MEMORANDUM

SUBJECT: East Grand Avenue Overlay District Zoning Study – Public Testimony and Revised Proposed Amendments

TO: Planning Commission

FROM: Comprehensive and Neighborhood Planning Committee

IMAGE B- (2x) 2-bed & (2x) 1-bed units

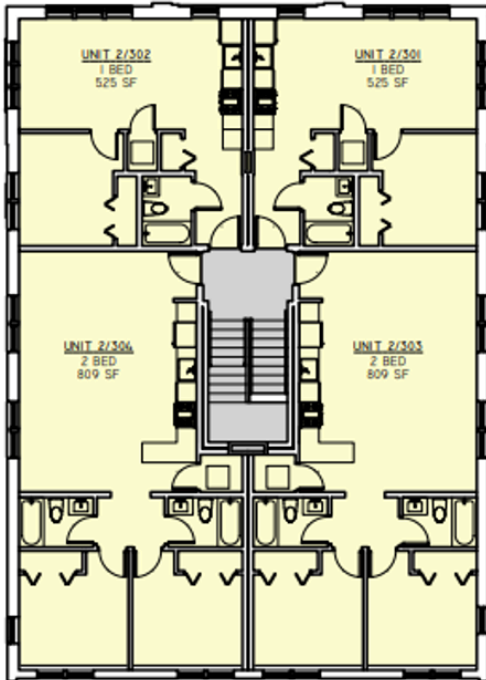
Image B on the left below shows the 3rd floor of the building without stepbacks includes two 2-bed units and two 1-bed units . **Image C** on the right shows the stepbacks as proposed would result in the loss of >50% of the built square footage and two 2-bed units. **Under these conditions, no project would be built.**

In a development with the stepbacks pictured on the right:

- The cost of land, design, utilities, fire protection and facade would stay the same
- The cost of framing would increase with added complexity
- The rent generated by the project, which is required by lenders and investors, would decline due to the loss of multiple units

1. **Sustain Saint Paul's highest-priority proposed change, Side & Rear Yards:** Stepbacks should only apply to front yards, or corner-side yards on projects with >200' of street frontage (e.g. 150' typical lot depth + >50' Grand Ave frontage). Rear yards should not have any step back requirement.

3. **Change the Stepback Threshold:** Increase the current 30' height threshold triggering a 10' stepback to a 40' threshold.

Response: The proposed required 10-foot stepback from all minimum setback lines for heights above 30 feet could limit smaller-scale development, especially on lots narrower than 60 feet wide. Modern construction methods and market preferences require taller building heights of 32-40 feet for three-story buildings, with 10.5-12-foot residential stories and 12-15-foot commercial stories. Requiring building heights above 30 feet to step back from all minimum setback lines would render many projects above two or three stories unviable due to the loss of square footage and very narrow upper floor space. A revised stepback requirement for buildings taller than 40 feet is supported for several reasons:

- It allows greater flexibility for achieving three stories without stepping back. The current EGAOD establishes a three-story maximum, so it is logical for the proposed updated EGAOD to allow three-story development on all lot sizes without additional restrictions.
- 40 feet is close to the 39-foot maximum building height in the new H2 residential district, the prevalent zoning district for Lincoln Avenue and Summit Avenue properties across the alley from Grand Avenue.
- 40 feet is the approximate height where pedestrians lose a visual connection to upper stories, and vice versa. Building design and development is most human scaled at or below 40 feet, contributing most substantially to pedestrian friendliness and street vitality.

Changing the setback depth from 10 feet to “a distance equal to the additional height” matches how the T districts and some B districts manage taller heights above a certain height or adjacent to lower-density residential districts, requiring angled setbacks that increase in depth as the building increases in height. Requirements for setbacks from all minimum setback lines above a certain building height can still limit development to three stories on smaller lots. A revised setback requirement that applies only along front yards, side street yards, and rear yards along the alley would increase flexibility while addressing height and scale concerns (see below).

** 800 Grand Ave, 3 stories (0 setback from both)*

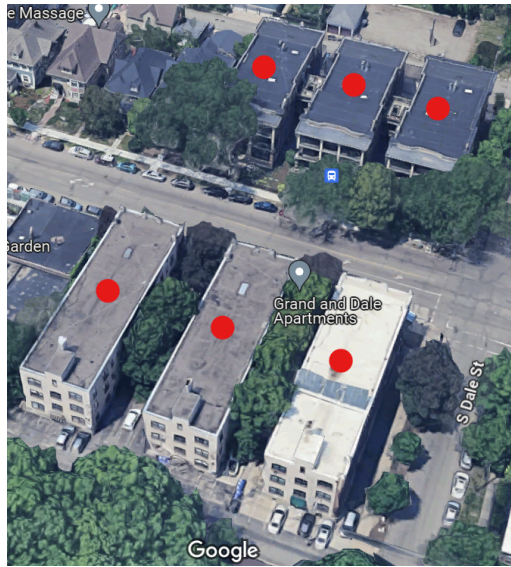
Appendix: Examples of existing Grand Avenue buildings east of Virginia that would be prohibited to build under the current proposed overlay district

excerpt from page 4.

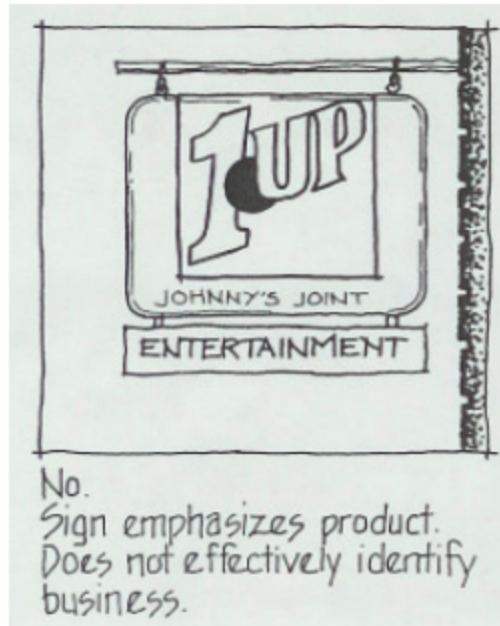
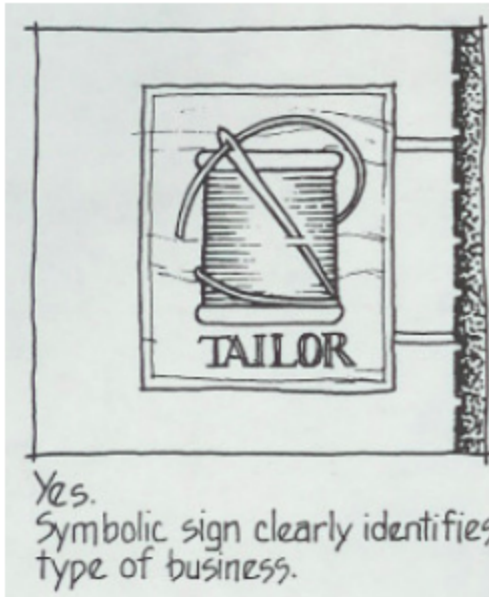
Focus on the Business name instead of a product placement.

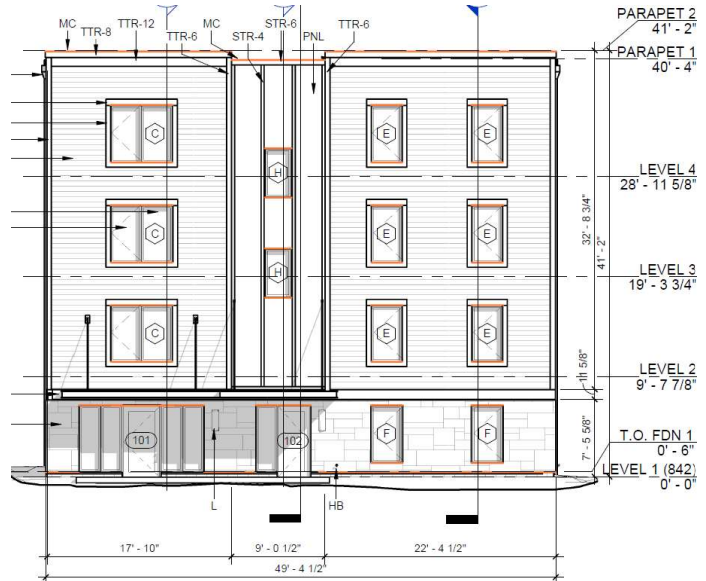
At 41' tall, this is abnormally short for a 4-story building. Each floor has only 8' ceilings, and thinner trusses were used between floors (**at great additional expense**) to shorten the building height.

Buildings with ground floor commercial, like we want on Grand Avenue, are **universally taller**. In a more typical building, the **step back would therefore occur starting on the 2nd floor...exacerbating the impacts illustrated below.**

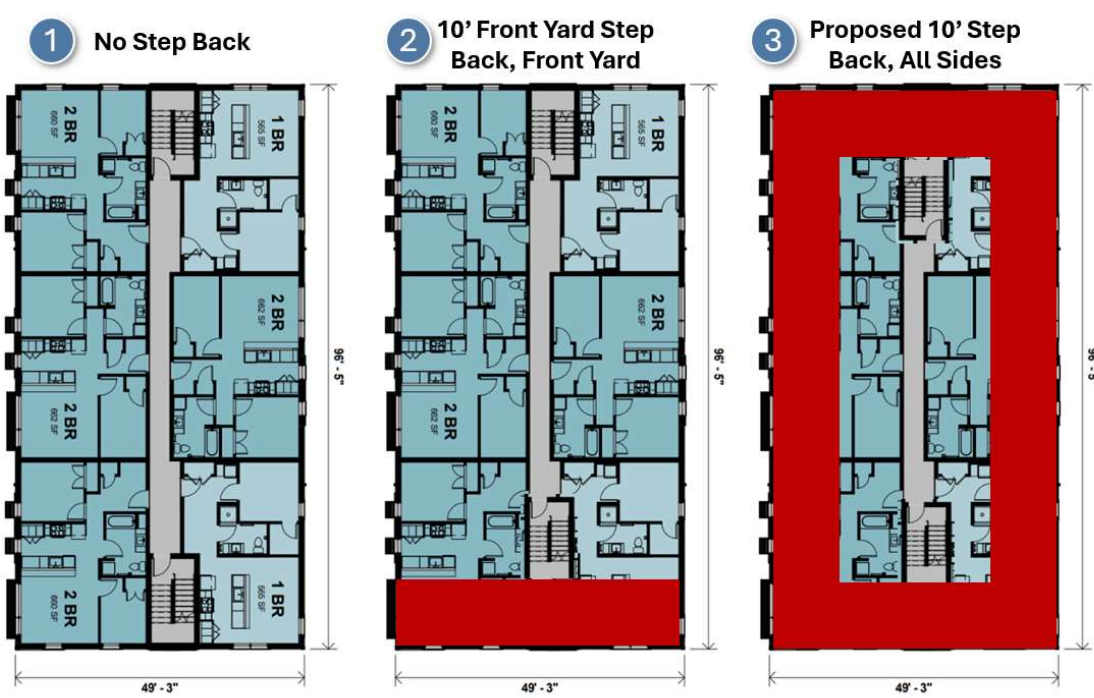
Image #3 below shows the current stepback proposal of 10' on all sides of the building. The 4th floor is mostly hallway & stairs, with poorly functioning, bowling-alley shaped units. In this scenario, no 4th floor would be attempted. **With only 3 stories of units, and the high cost of land on Grand Avenue, the project would be economically inviable. No bank or investors would fund it.**

In Image #2, we see that having a 10' step back on just the front yard of the building would **eliminate 2 entire homes**. The loss of these units still **make the project economically inviable.**
